To: T10 Technical Committee
 From: Thomas Grieff, HP (thomas.grieff@hp.com)
 Date: 23 September 2002
 Subject: T10/02-300r2 SAS OOB and DWS state machine updates

This revision incorporates technical changes to the state machines and editorial changes (developed with George Penokie, IBM) to the OOB/phy reset sequence descriptions prior to the state machines.

Figure 44 — SAS phy (SP) state machine - OOB sequence states

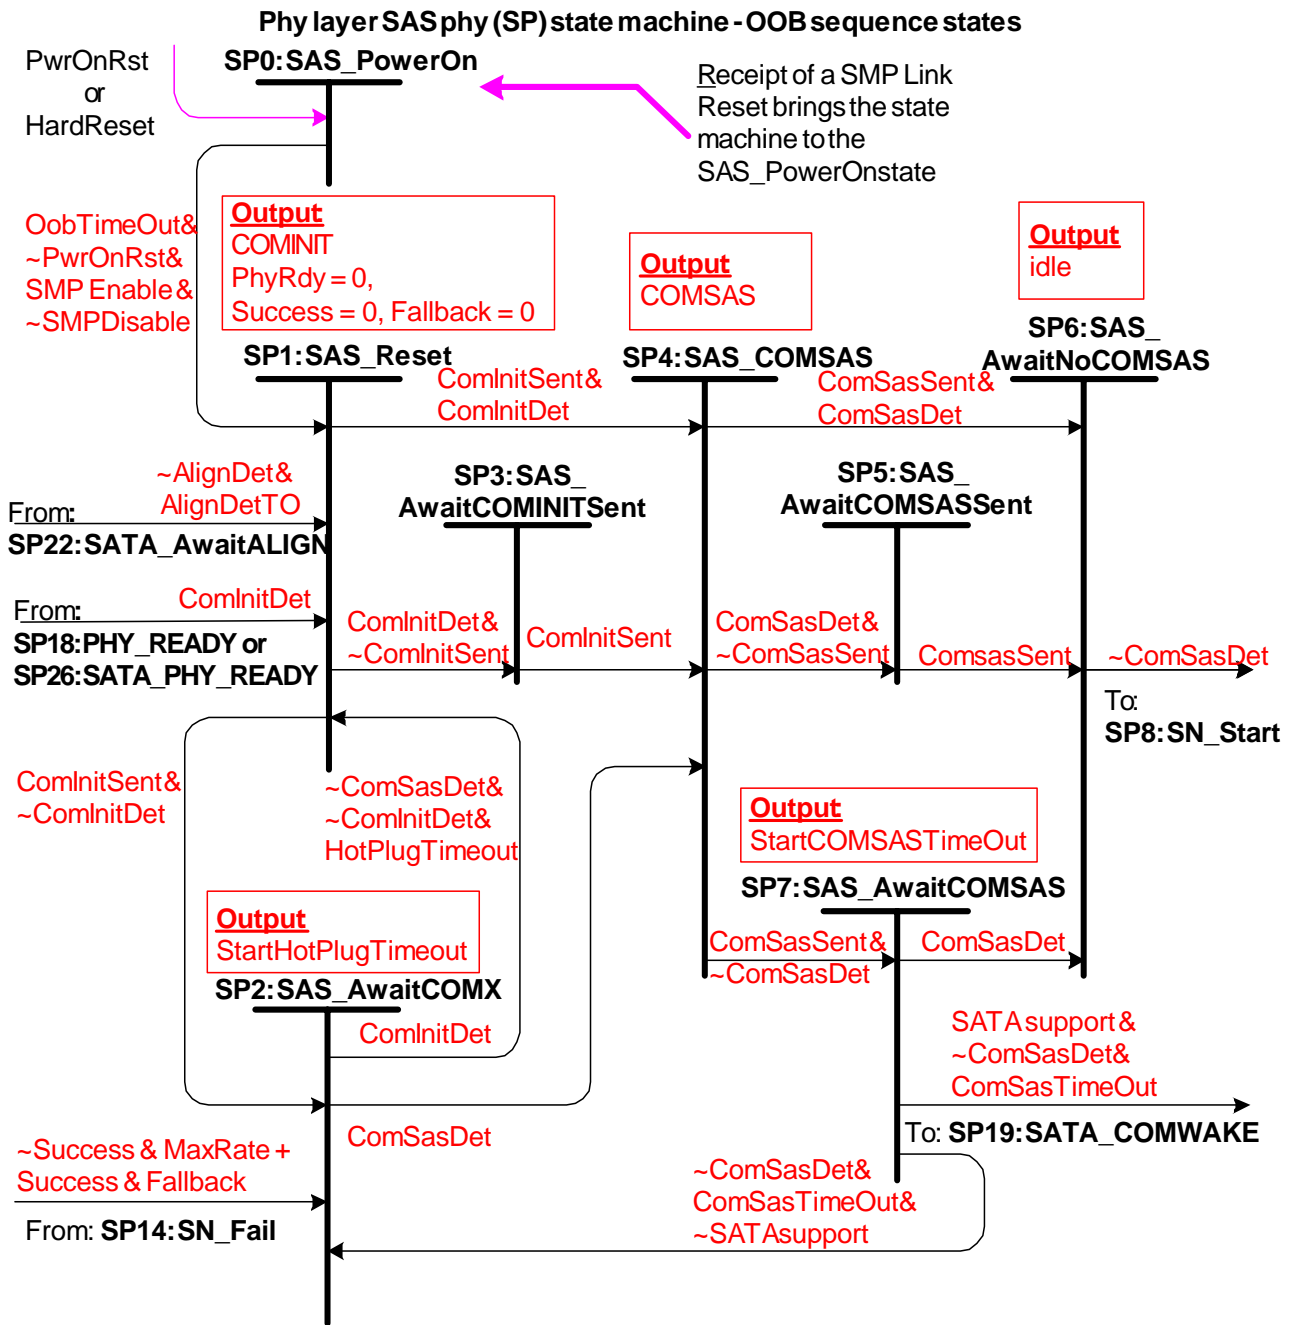
Figure 44 shows the OOB sequence states, in which the SAS device transmits an initial COMINIT and COMSAS sequences, and awaits to receive a COMINIT and COMSAS sequences back. These states include a prefix of SAS_ in the state name. Once a COMINIT has been detected, the SAS device transmits a COMSAS sequence instead or in place of the normal SATA calibration pattern, and waits to see if the connected device responds with a COMSAS. If the SAS device does not detect a COMSAS sequence within a COMSAS Detect Timeout period, it assumes that a SATA Device is attached, and jumps to the SATA Host

emulation states. Otherwise, a SAS-capable port is attached and the SAS speed negotiation states are entered.

Figure 45 — SAS phy (SP) state machine - SAS speed negotiation states

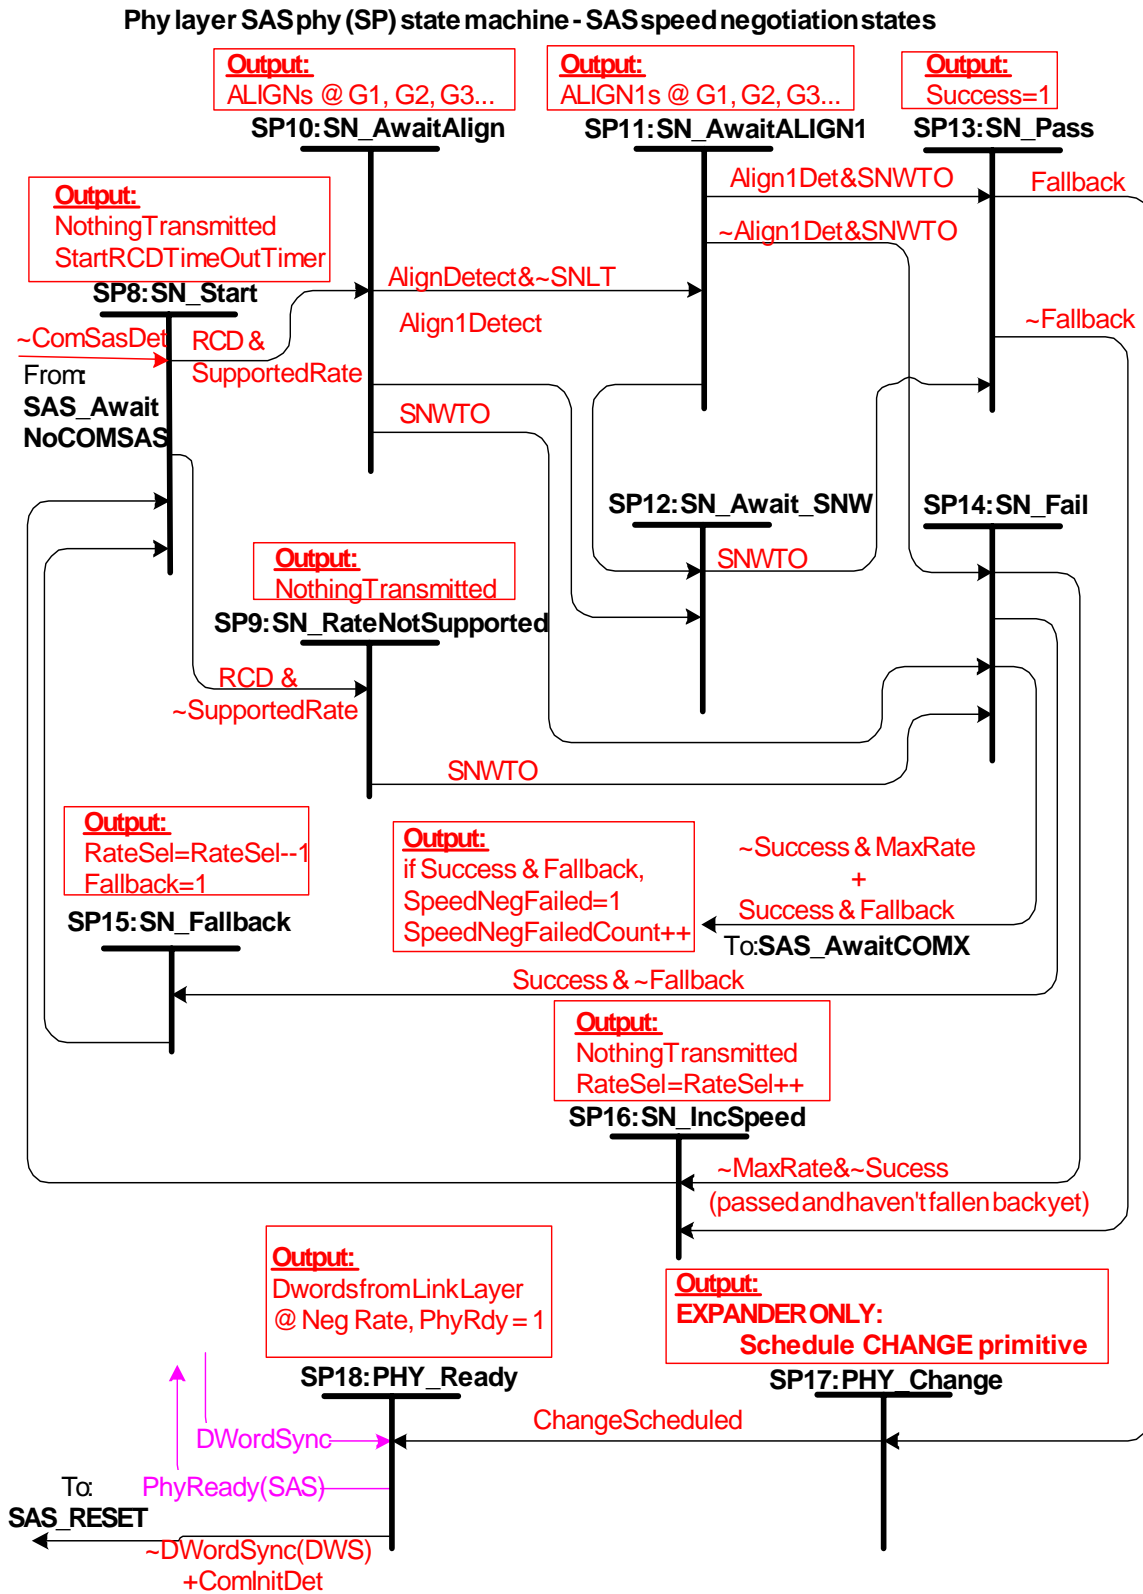
Figure 45 shows the SAS Speed Negotiation states, in which the SAS phy has detected that it is attached to a SAS phy, and engages in the SAS speed negotiation procedure. These states are indicated by state names with a prefix of SN or PHY.

Figure 46 — SAS phy (SP) state machine - SATA host emulation states

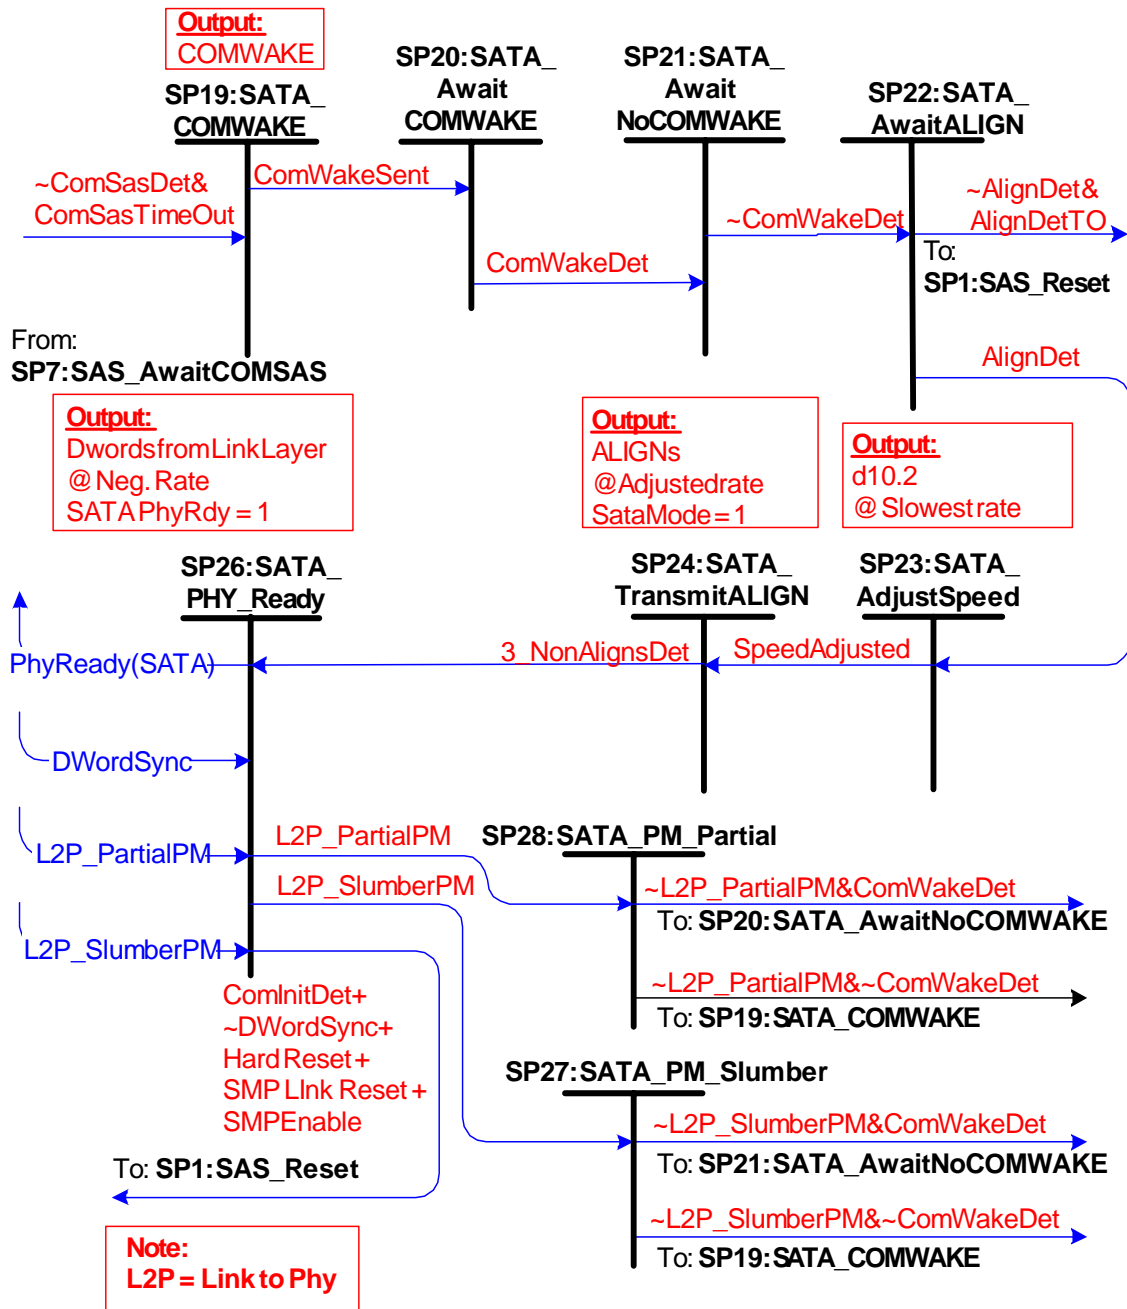
Figure 46 shows the SATA Host emulation states, in which the SAS device has detected that it is attached to a SATA target and behaves as if it were a SATA host as far as OOB is concerned, initiating the speed negotiation. These states are indicated by state names with a prefix of SATA_. During SATA Host emulation, the SAS device transmits a COMWAKE sequence and then waits to receive a COMWAKE. Once the COMWAKE sequence is detected, the SAS device follows the speed negotiation sequence defined in the SATA 1.0 specification.

Figure 47 — Dword synchronization state machine

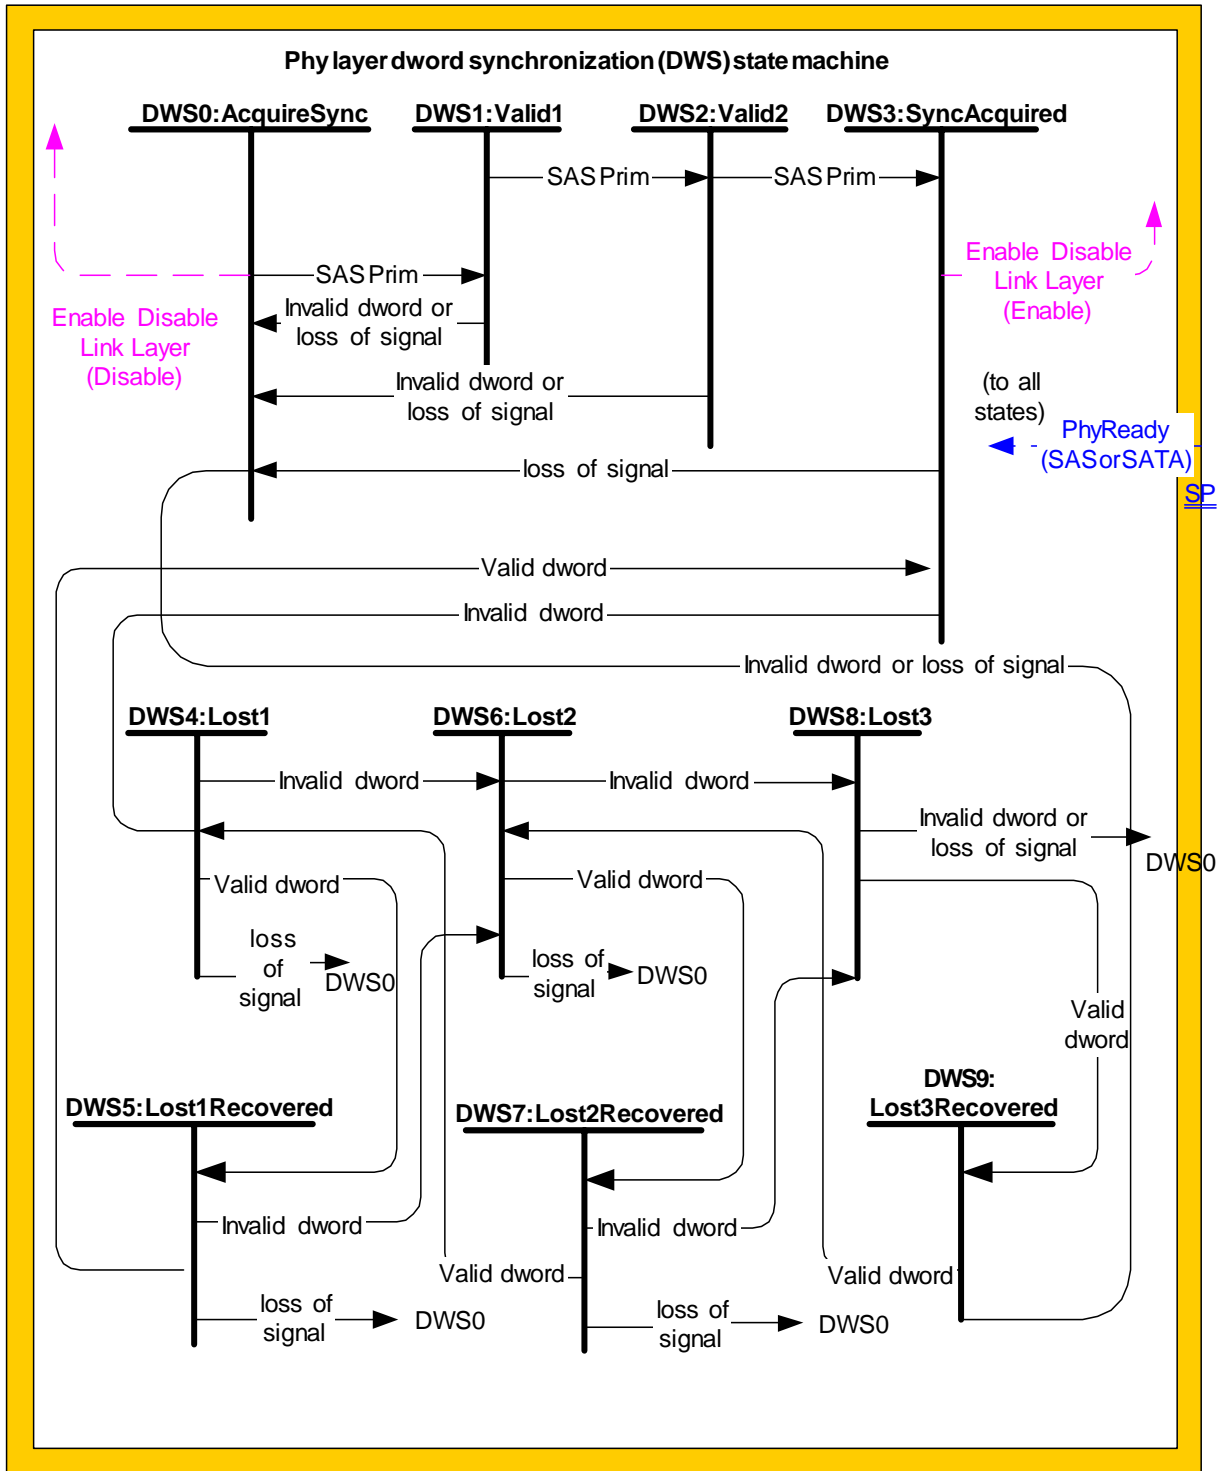
Figure 47 shows the DWS state machine.
